DATE: January 25, 2022
TO: Blue Bird Owners
Subject: Recall R20AO, FMVSS 105 Noncompliance – Hydraulic Brake Units W/Floor Mounted Park Brake Hand Lever Assembly

IMPORTANT SAFETY RECALL NOTICE
NHTSA Campaign Number: 20V-234 (School Bus)
NHTSA Campaign Number: 20V-235 (Non-School Bus)

R20AO Hydraulic Brake Floor Mounted Hand Lever Setting

Photo A

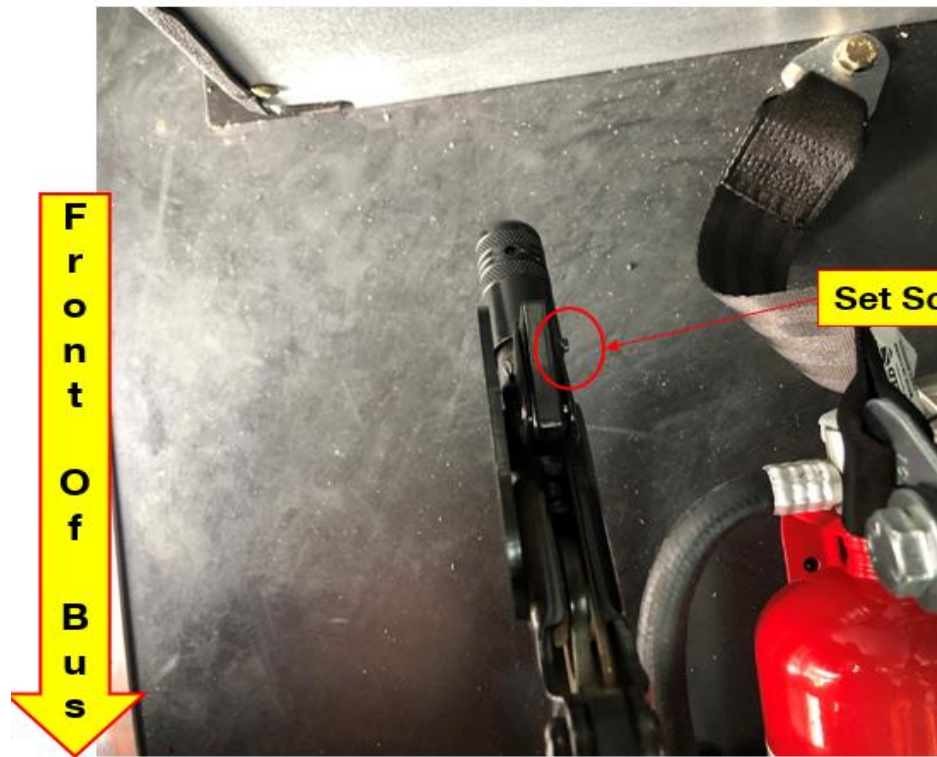
1. Place the park brake handle in the released position.
2. Attach a 16" rope tied into a loop if your force gauge is not equipped with a loop strap. (Reference Photo A)
3. Slowly pull up the hand lever to the peak park brake applied location. (Reference Photo B)
4. Pull several times to verify the setting.
5. If the force setting is 90 to 95 FT lbs. No other actions are required.

Photo B

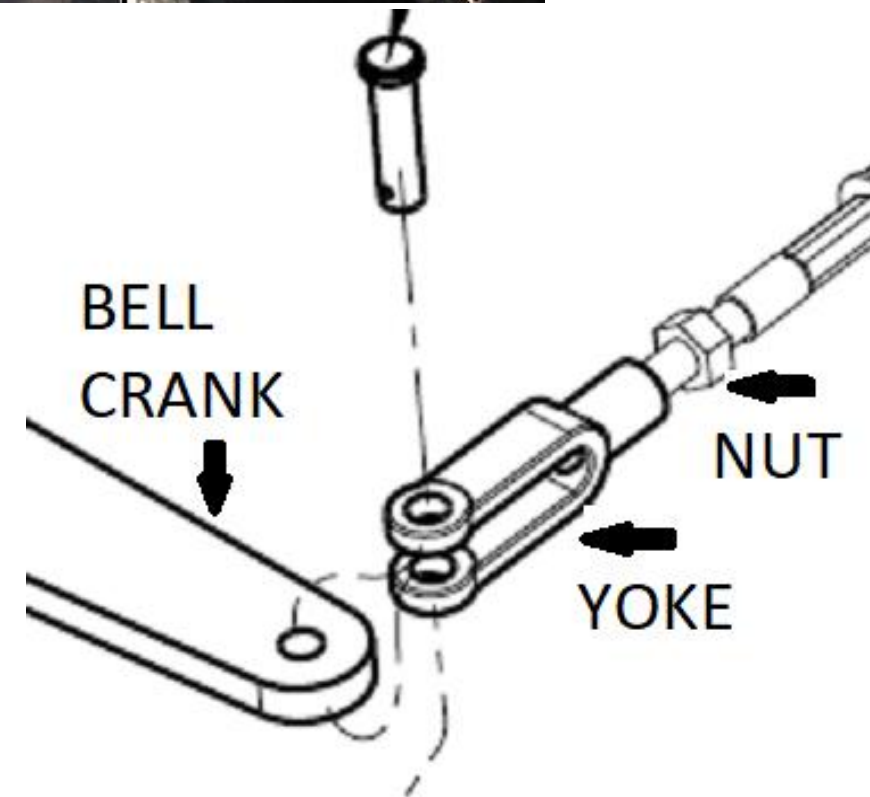
1. Use the instructions below to confirm the setting of the park brake handle, in the released position.
2. Attach the force gauge to slowly pull up the hand lever to the peak park brake applied location. (Reference Photo B)
3. It is important to keep the force gauge direction of pull at a 90-degree angle to the lever, as the lever rotates to the park brake applied location.
